10-1– 12

Chapter 10, Chapter 11

Proposed Change as Submitted

(d) Clearance with lavatory overlap

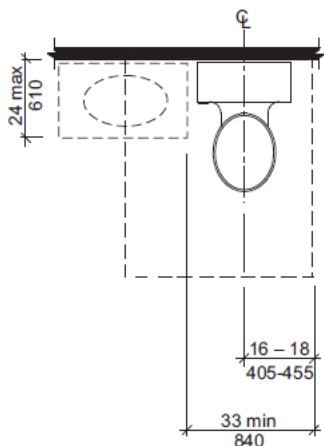
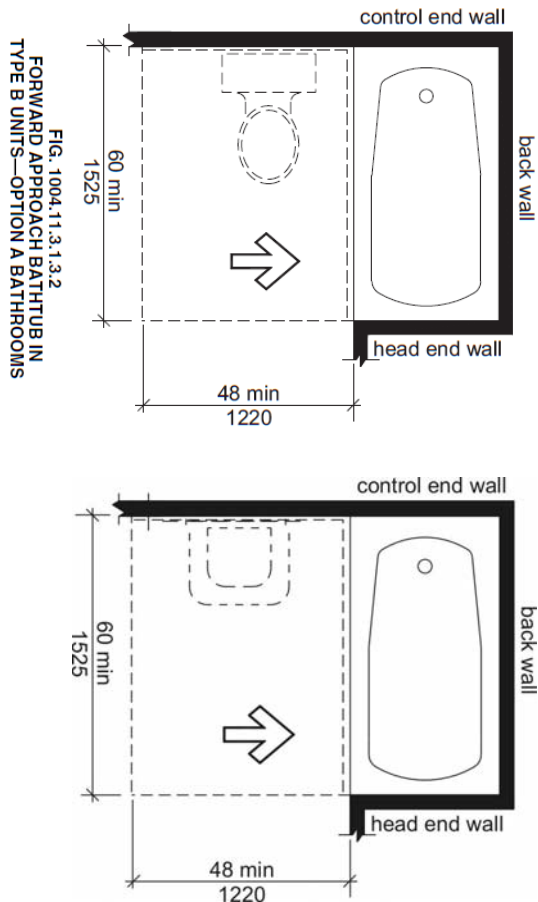
1004.11.3.1.3.2 Forward Approach Bathtubs. A clearance 60 inches (1525 mm) minimum in length and 48 inches (1220 mm) minimum in width shall be provided in front of bathtubs with a forward approach. Either a water closet or a lavatory or both a water closet and a lavatory shall be permitted in the clearance at one end of the bathtub.

1004.11.3.1.3.2 Forward Approach Bathtubs. A clearance 60 inches (1525 mm) minimum in length and 48 inches (1220 mm) minimum in width shall be provided in front of bathtubs with a forward approach. A water closet, a lavatory, or both a water closet and a lavatory shall be permitted in the clearance at one end of the bathtub.

This is simply a clarification that may be helpful given several changes that occurred in the 2009 edition and dealt with the way the word “and” was used for requirements. This perceived problem may be caused by being too code literal, but the use of the word “and” as the conjunction does raise the question as to whether the encroachment is only allowed for situations where both the water closet and lavatory exist or whether the encroachment is also allowed when only one of those fixtures is within the space.

Because of the word “and” in the phrase “a water closet and a lavatory” it may be assumed to require both fixtures and not allow a water closet OR a lavatory. The word “and” is good because if you provide both a WC and a lav along the end wall you could end up with both of them extending into the required clearance (the first would be in it completely and the second would encroach just a bit based on the clearance between fixtures). [See fig. 1004.11.3.1.2(d) below for example of how both fixtures may encroach.]

Changing the word “and” to be “or” would seem like a possibility but that would not accept the second fixture extending into the space as discussed above. Because the text needs to accept either one fixture or both fixtures in the space, it may need to be changed to something like what is shown in the two options.
